DESIGN CHANGES

Project	COUNTY FLATS, SANDFIELDS
Project number	N297/2
Client	HALE CONSTRUCTION LTD
Title	BLOCK 05/06 ELEVATIONS 2/2
Drawing number	A016A
Scale	1 : 100 at A1
Revision	K
Status	INFORMATION
Drawn	PC
Date	30.11.21

01 E08 Block 5 Open Public Space Elevation
1 : 100

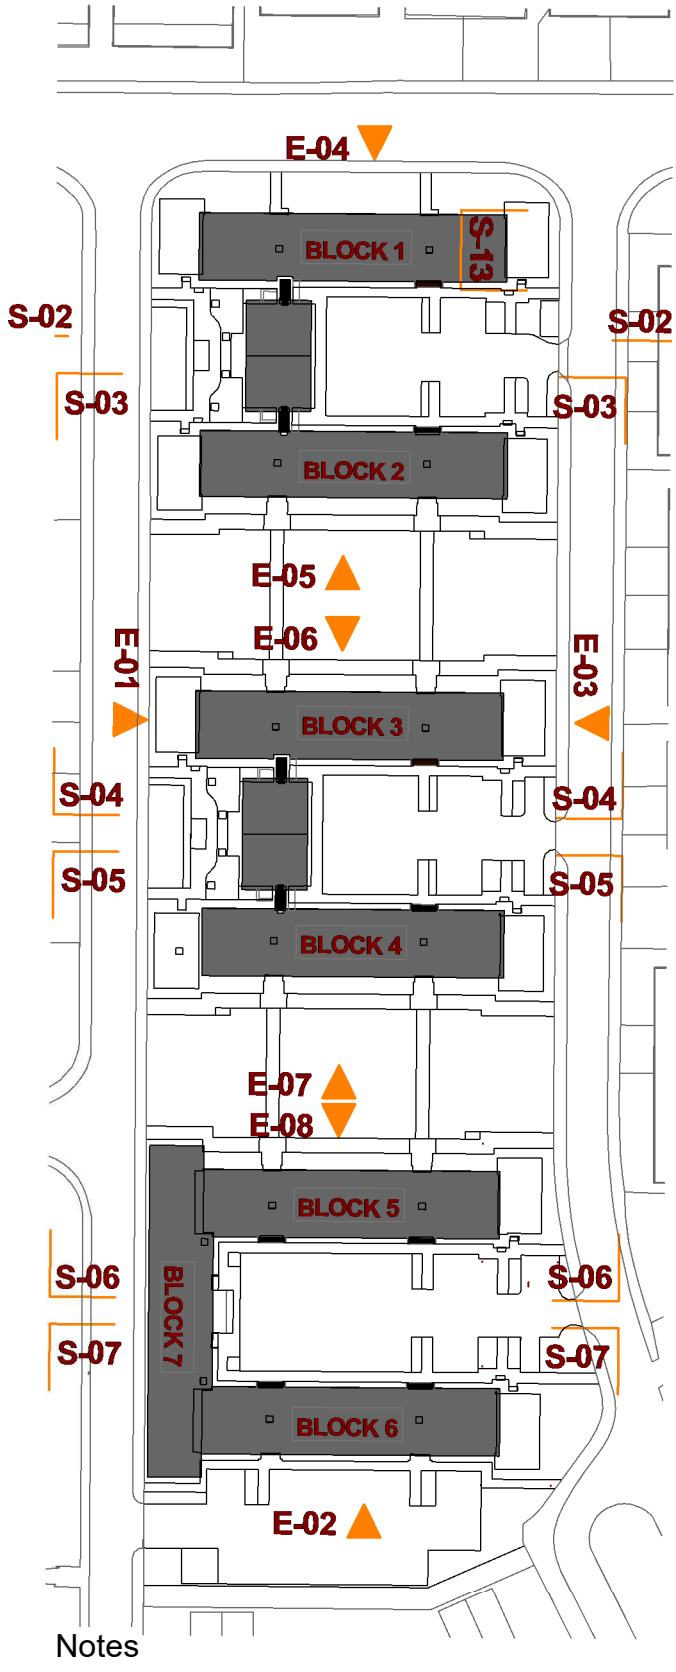
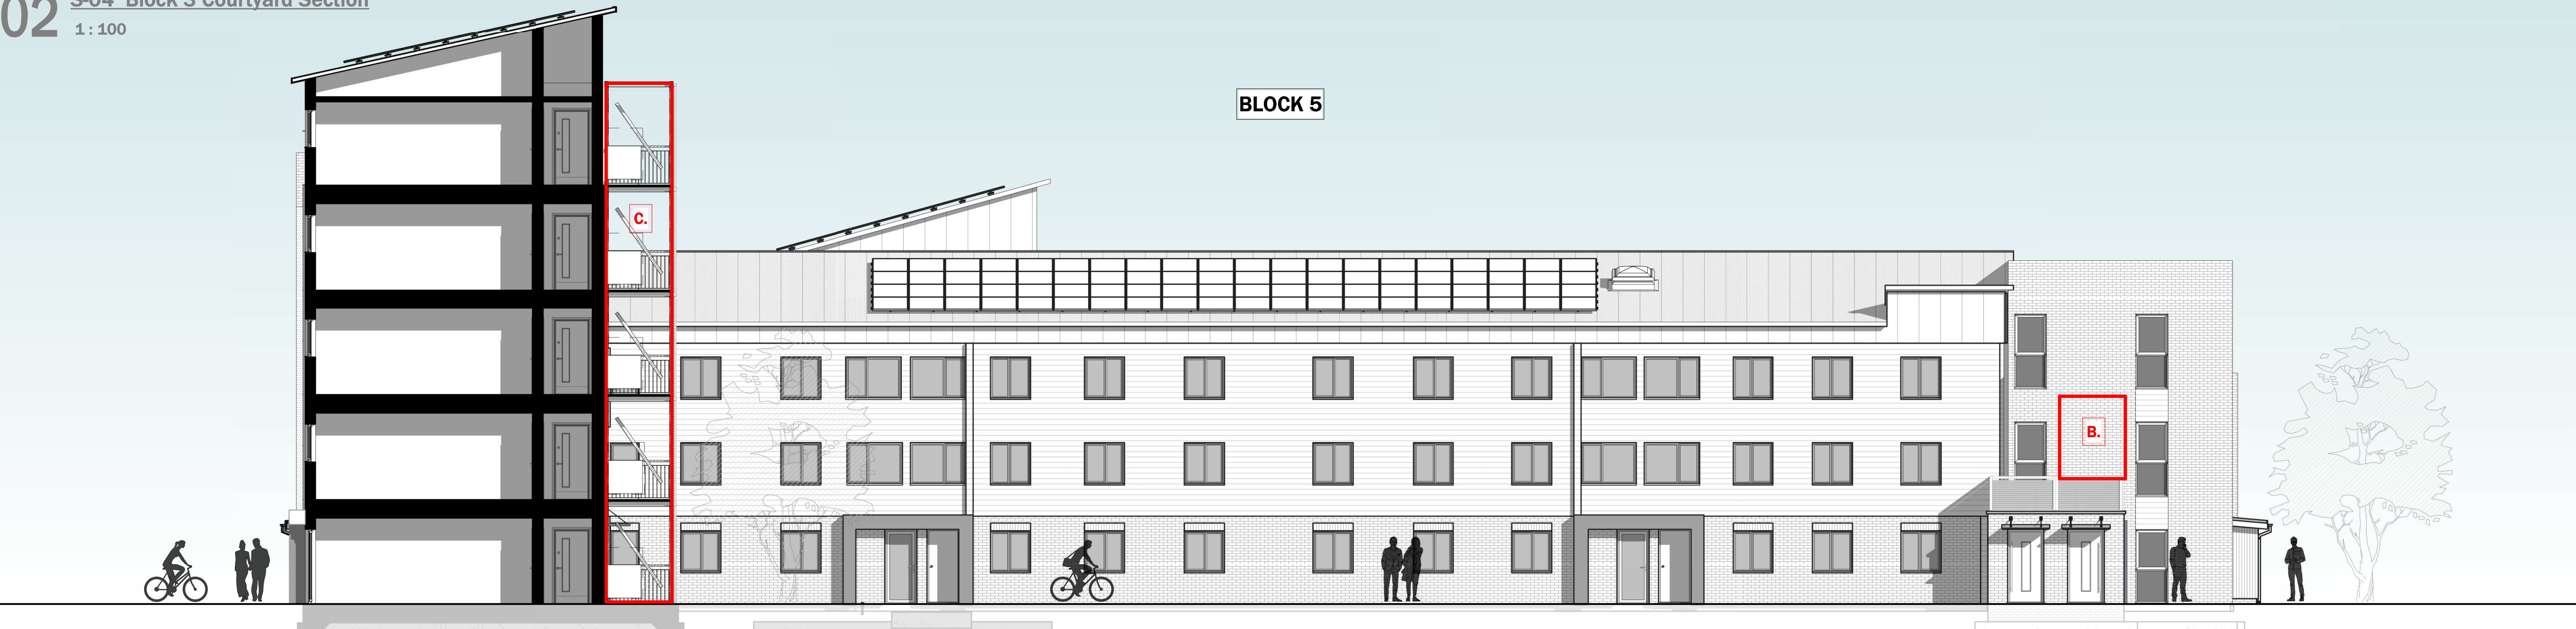
B. LOUVRED ENCLOSURE HEIGHT REDUCED TO APPROX 1M OVER PORCH ENTRANCE AND MADE WIDER TO MATCH PORCH WIDTH

C. SIDE LOUVRES TO AIR SOURCE HEAT PUMP ENCLOSURE REMOVED AND REPLACED WITH 1100MM VERTICAL RAILINGS TO PROVIDE MANUFACTURERS AIR FLOW REQUIREMENTS
